200,000GAL ON-GROUND WATER TANK RELINING SIDNEY, MONTANA PROJECT No. WR2300035

200,000 Gal. on-ground Water Tank Relining Punchlist Sidney, Montana WR23-00-035

Re: 200,000 Gal On-Ground Water Storage Tank Relining

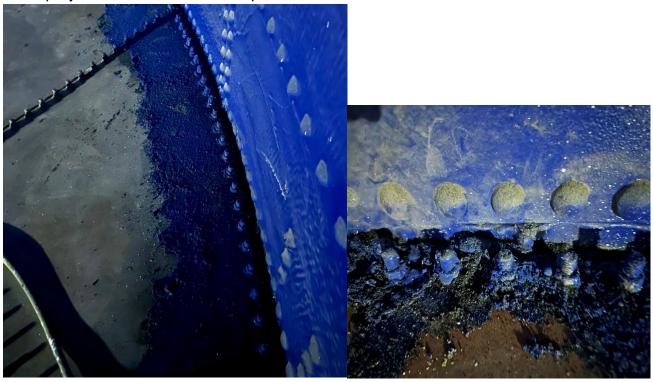
- 1. Visual spark testing needs to be completed in the presence of the RPR to the satisfaction of RPR. (Note: AL holiday detector not functioning. Unknown last accurate test)
- 2. Over Spray on exterior of tank around upper and lower hatches and vent, and on adjacent SCADA building. Picture of upper vent shown below for reference.

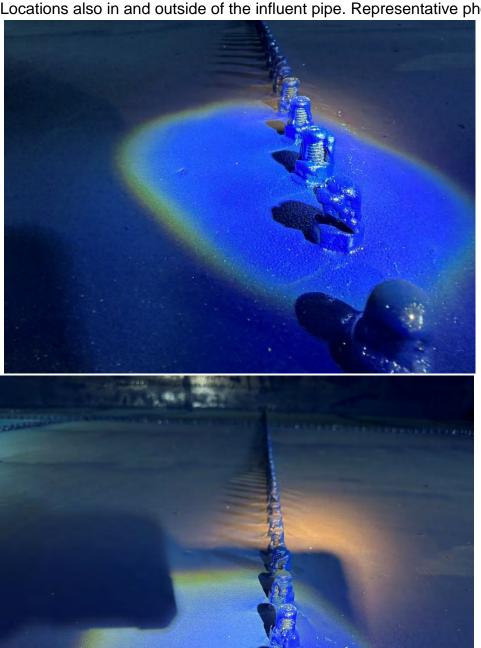
3. Overspray and debris on floor was primed over and relined.

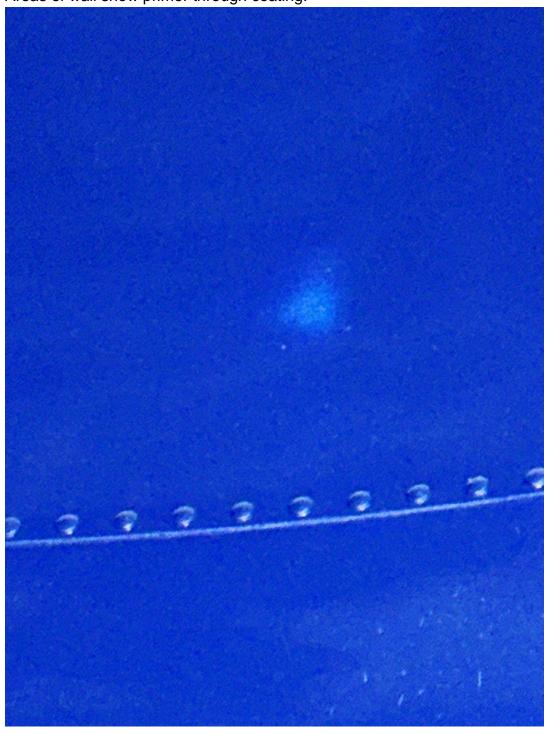
4. Numerous Areas on the floor show bare steel without coating, typically around the bolts. Locations also in and outside of the influent pipe. Representative photos.

FIGURE 1 - LEAK 1, LOCATION OF PREVIOUS AND EXISTING LEAK

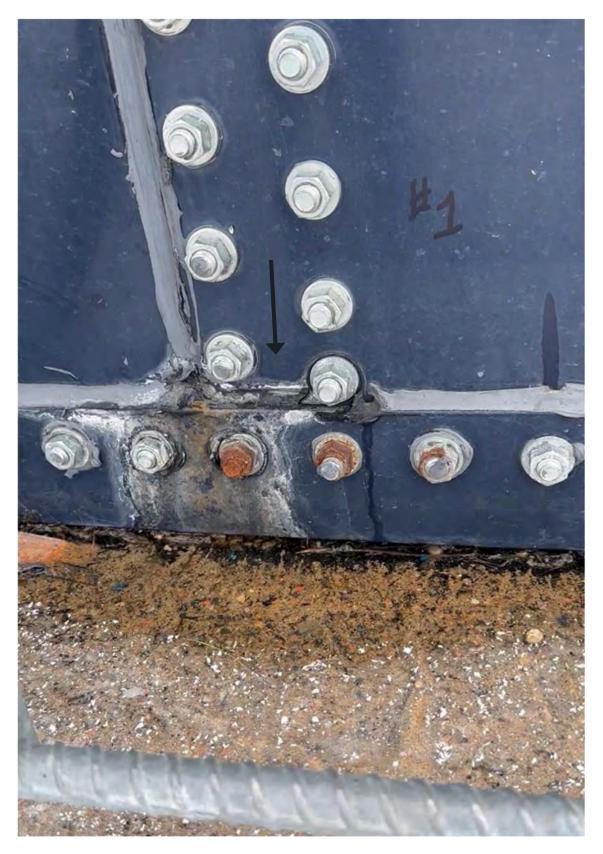
Leak #1: Tank position 11:40, Approximately 2.5 inches above ground level. This leak is visible outside of the tank at the seam.

FIGURE 3 - LEAK 3, LOCATION OF PREVIOUS AND EXISTING LEAK

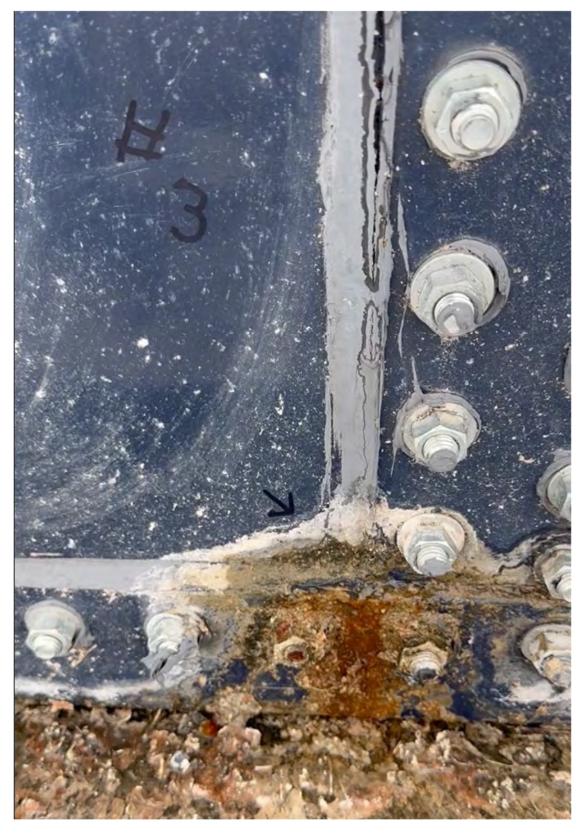
Leak #3: Tank Position 9:00, Approximately 2.5 inches above ground level. This leak is visible at the seam between the bottom flange, and the bottom wall panel.

FIGURE 5 - LEAK 5, LOCATION OF PREVIOUS AND EXISTING LEAK

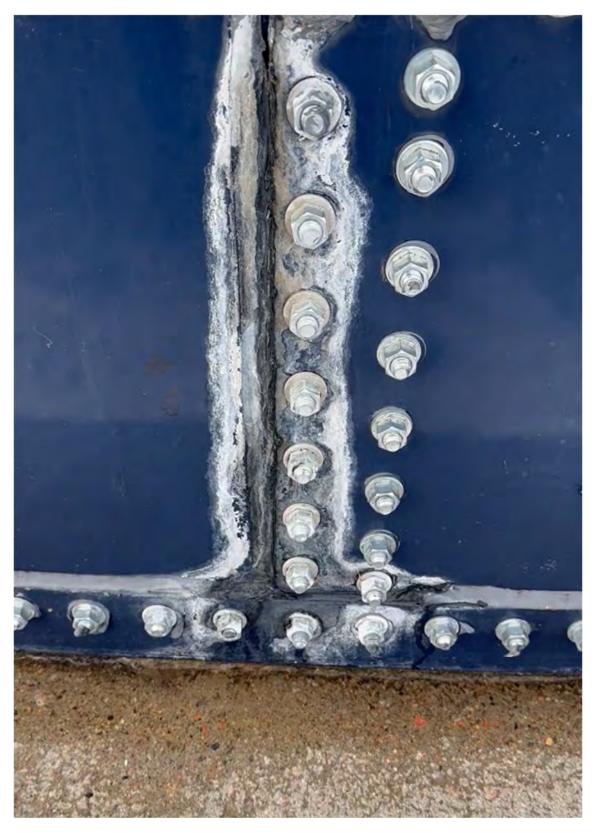
Leak #5: Tank Position 7:00, visible approximately 18 inches above ground level, along the seam.

FIGURE 6 - LEAK 6, FLOWING LEAK

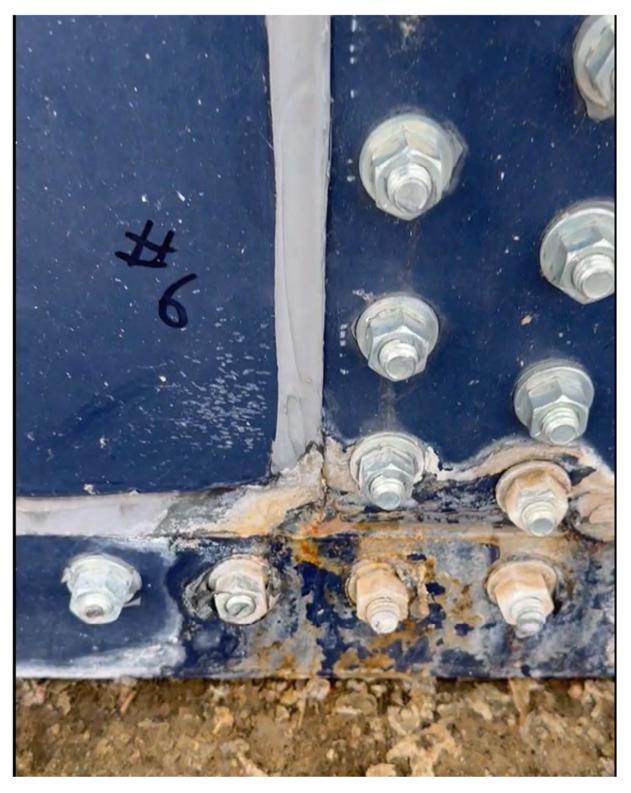
Leak #6: Tank Position 6:00, this is a flowing leak approximately 2.5 inches above ground level and is visible at the flange seam.

FIGURE 7 - LEAK 7, LEAK AT SEAM

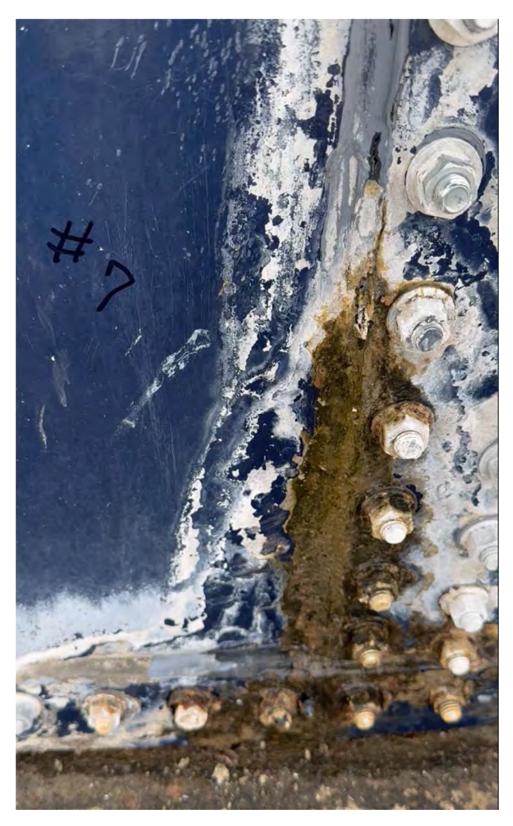
Leak #7: Tank position 5:00, is visible approximately 14 inches above ground level, along the tank seam.

FIGURE 10 - LEAK 10, PREVIOUS AND EXISTING LEAK

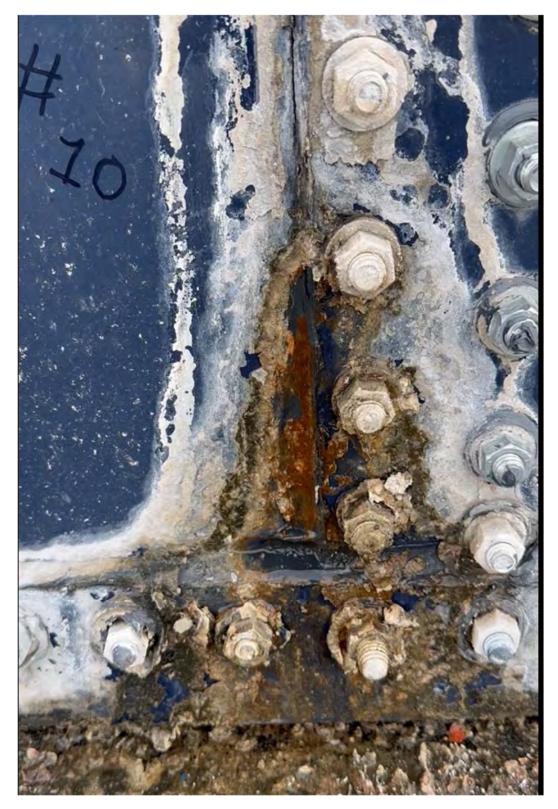
Leak #10: Tank Position 2:00, is visible approximately 6 inches above ground level at tank seam.

FIGURE 11 - LEAK 11, NEW LEAK FROM BOLTS

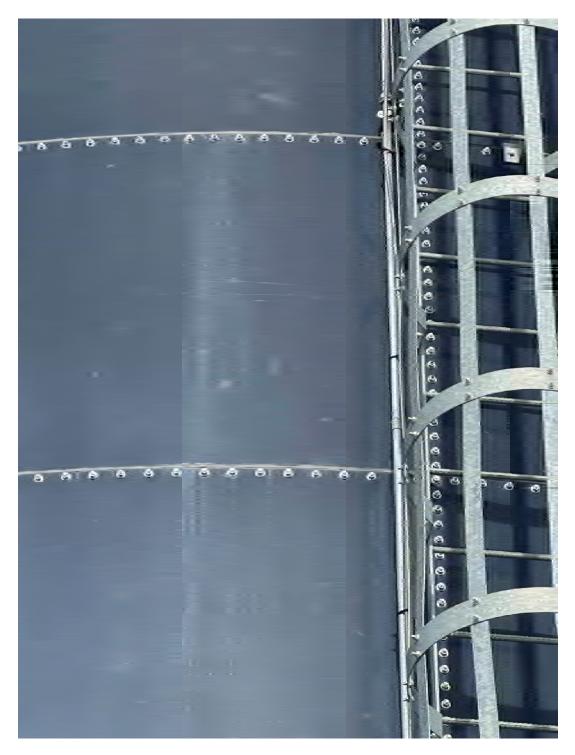
Leak #11: Tank Position 11:45, leak is visible approximately 26 feet above ground level, and flowing down the panel.

FIGURE 12 - LEAK 12, OVERFLOW PIPE

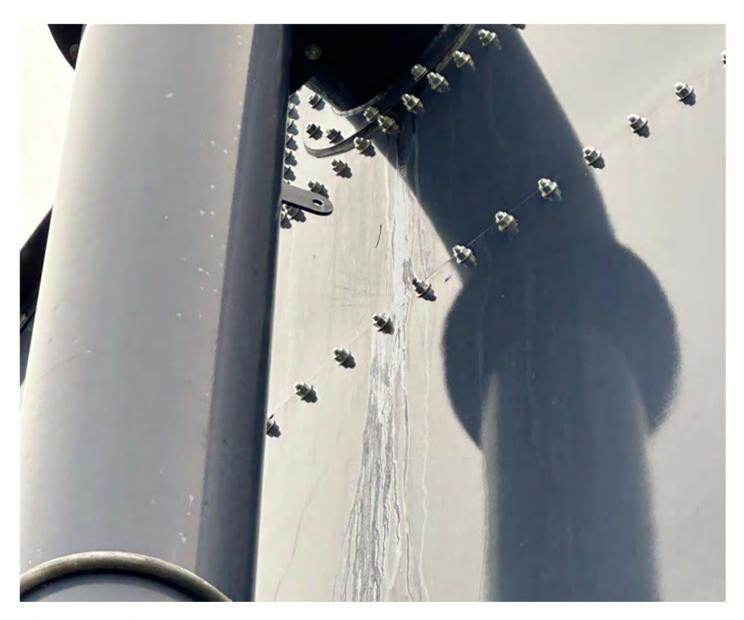
Leak #12: Tank position 3:30, is visible approximately 29 feet above ground level (Base of overflow). This leak is also leaking into the overflow pipe and is filling the overflow pipe with ice in freezing conditions.

FIGURE 13 - LEAK 13, FROM BOLT HOLES

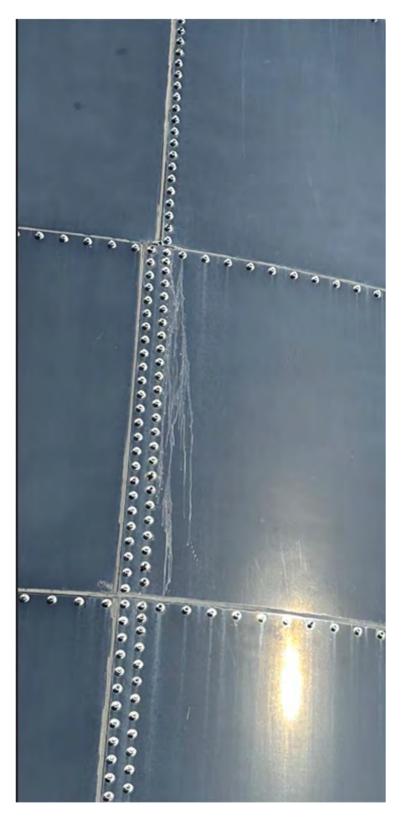
Leak #13; Tank position 1:00, approximately 13 feet above ground level. This is a new leak and is visible around the bolts. This was discovered on 11/7/23.
